SUNDRY NOTICES AND REPORTS ON WELLS

Devon respectfully requests an annular variance for the following wells:

10M BOPE & Closed Loop Equipment Schematic

Devon Energy Production Co.
Fighting Okra 18-19 – Multiple Wells
NMNM114992

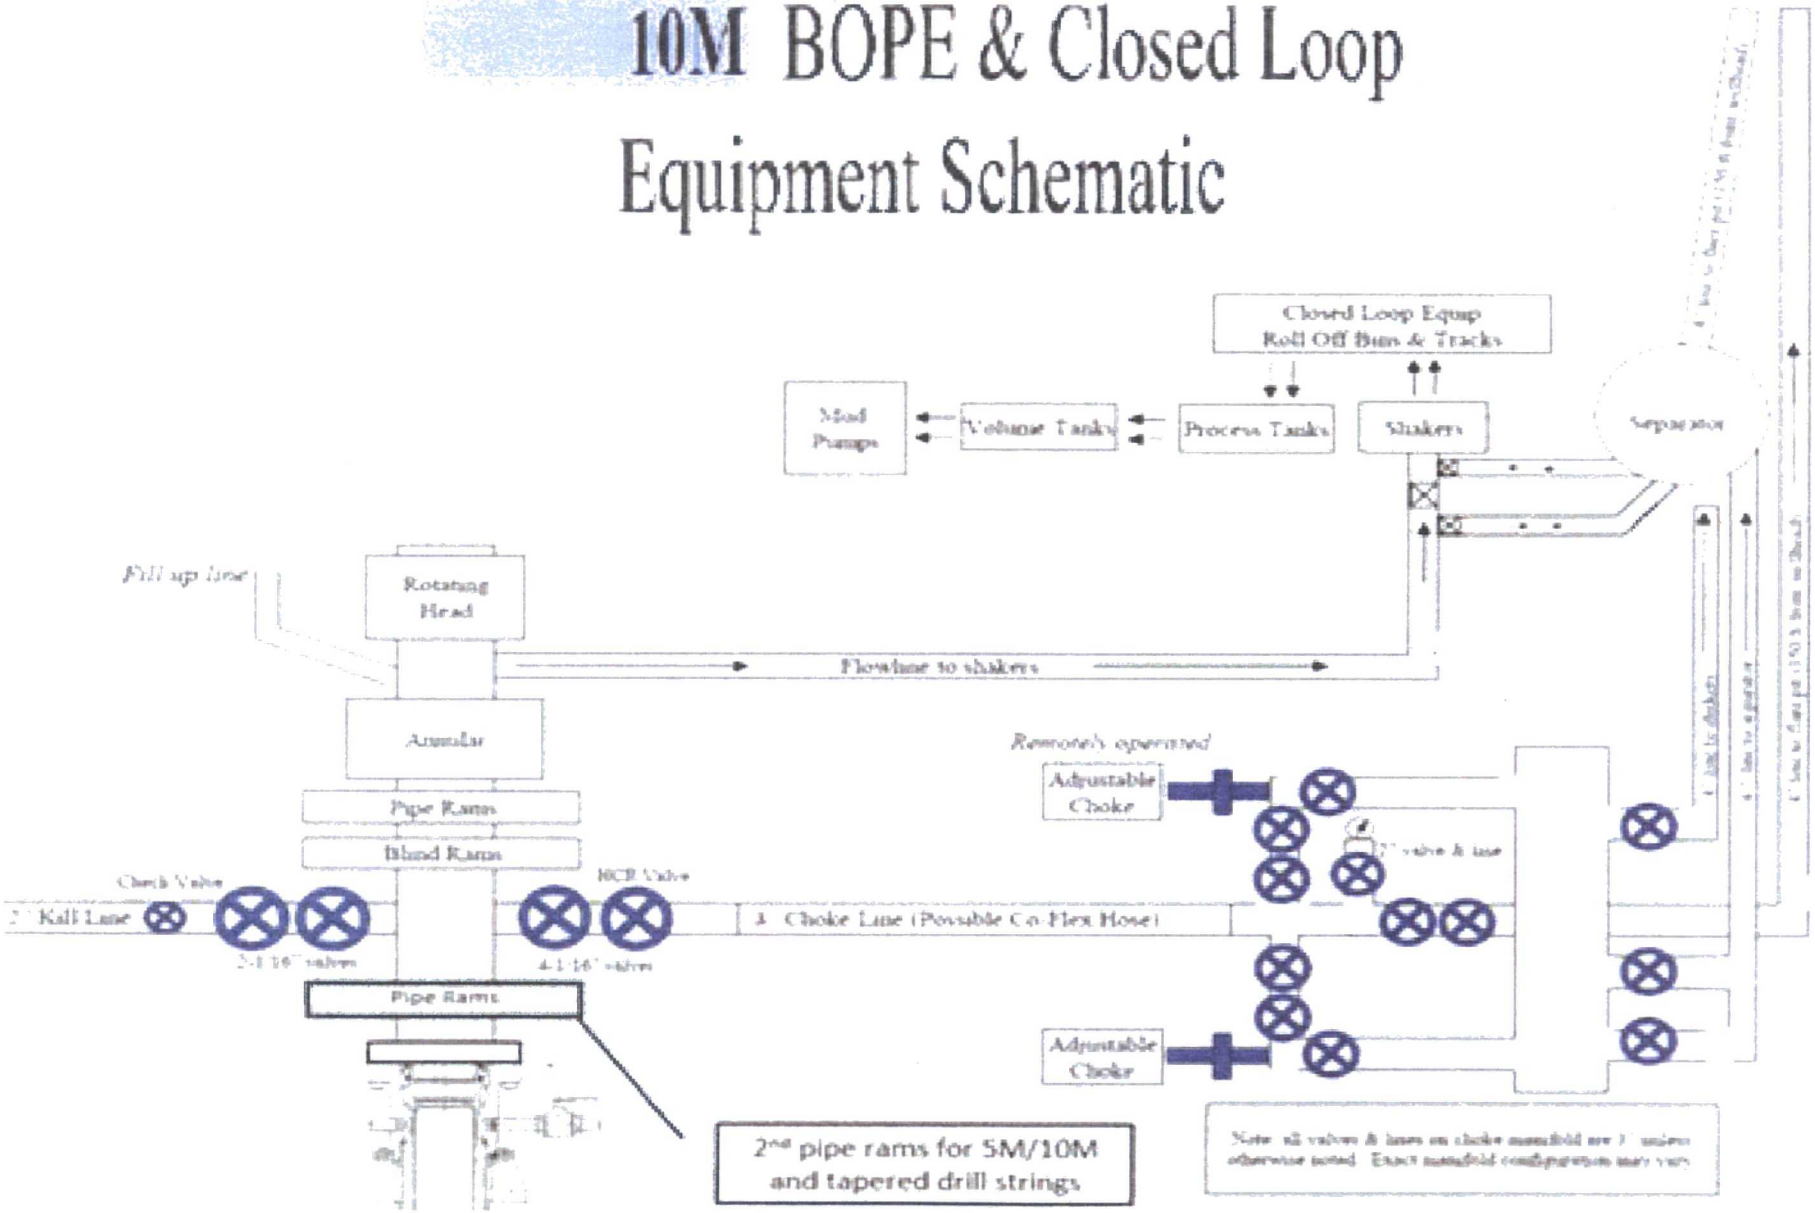
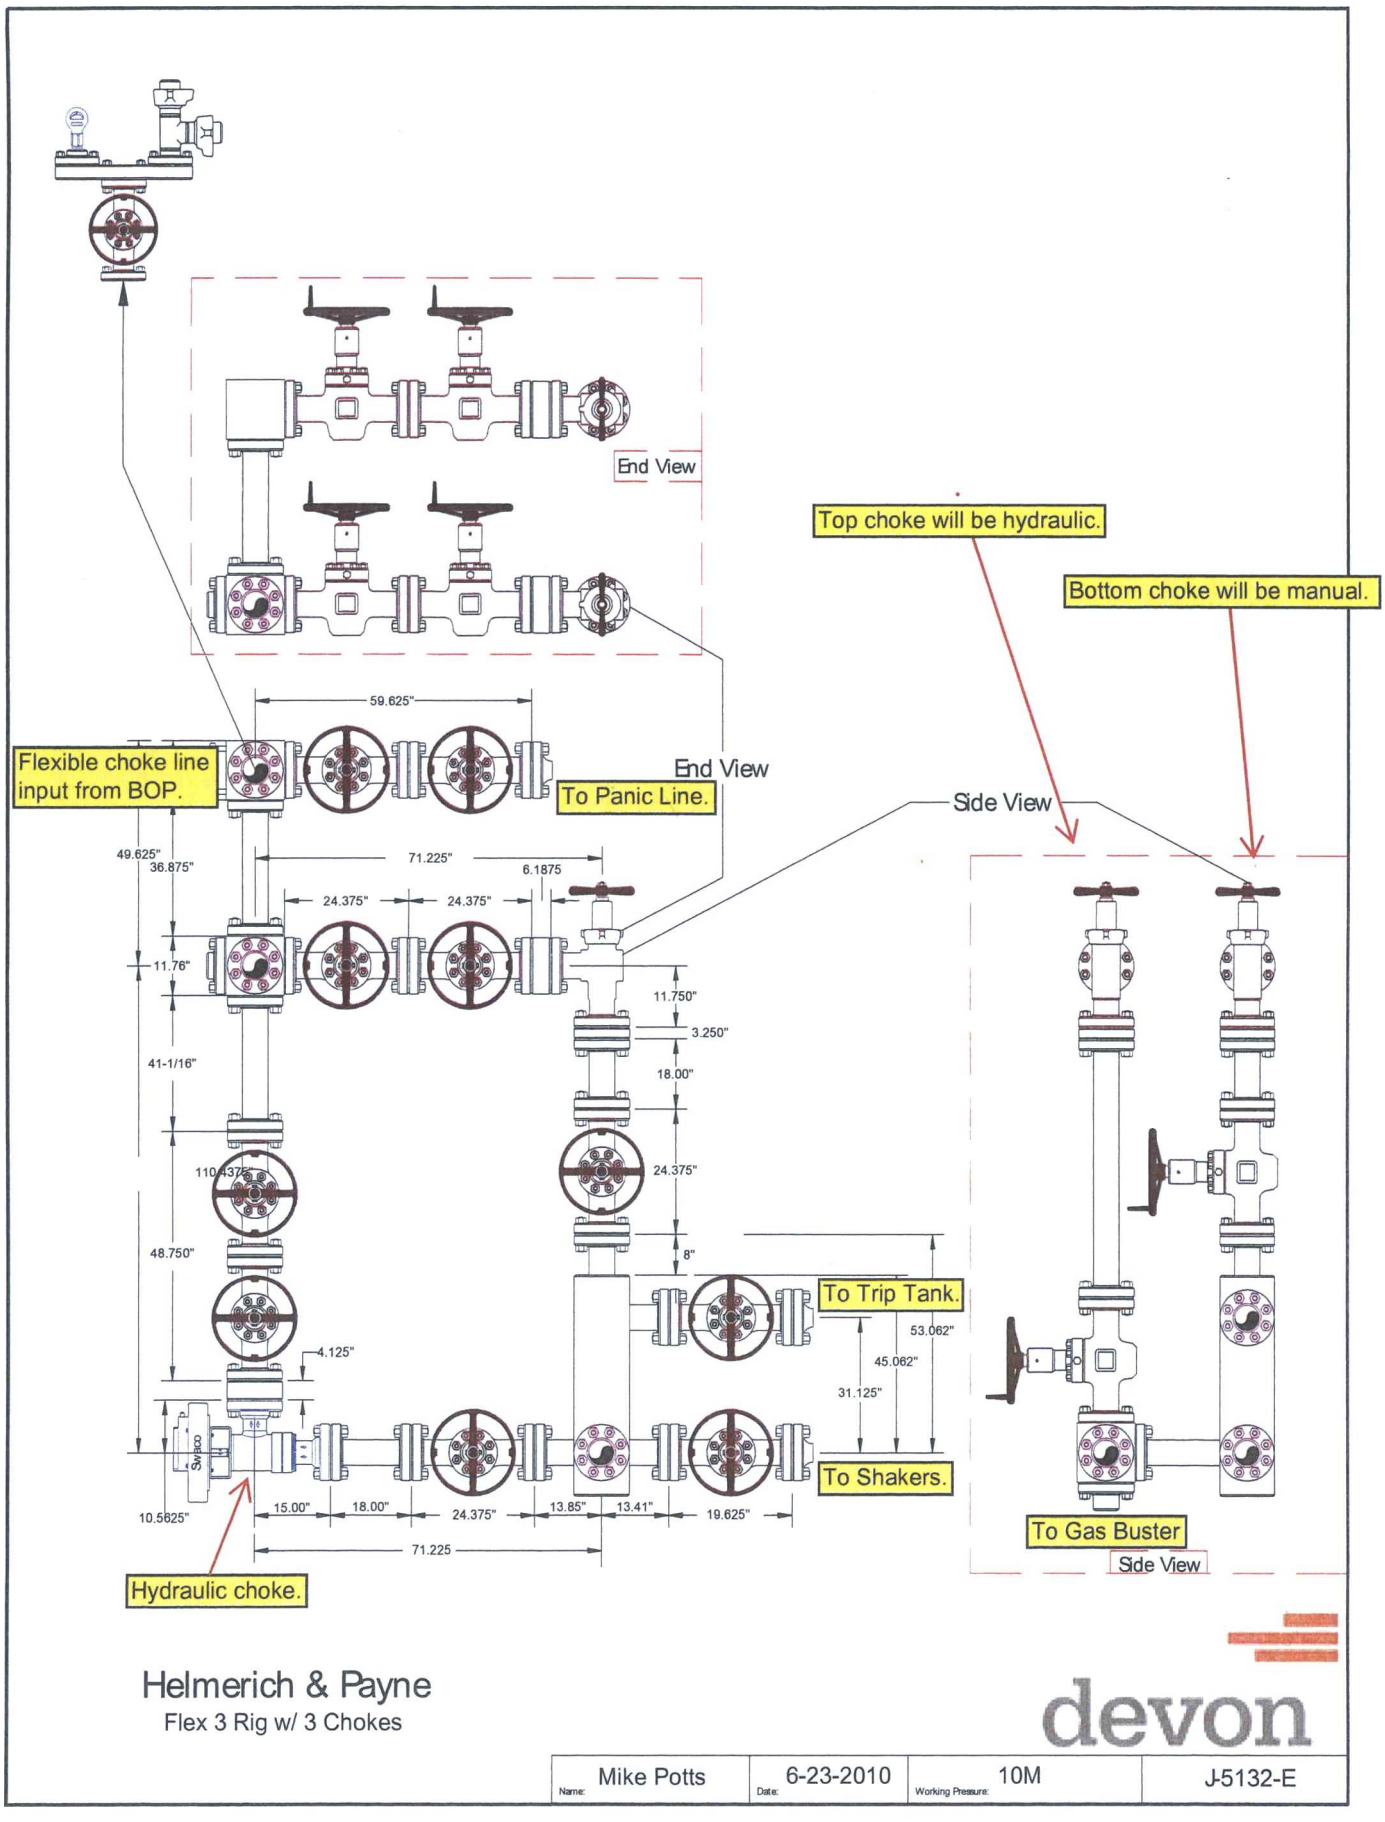
Please see attached BOPE Schematic and Annular Preventer document.

2. **Variance is approved to use a 5M annular on a 10M BOP. The annular must be tested to full working pressure (5000 psi.)**
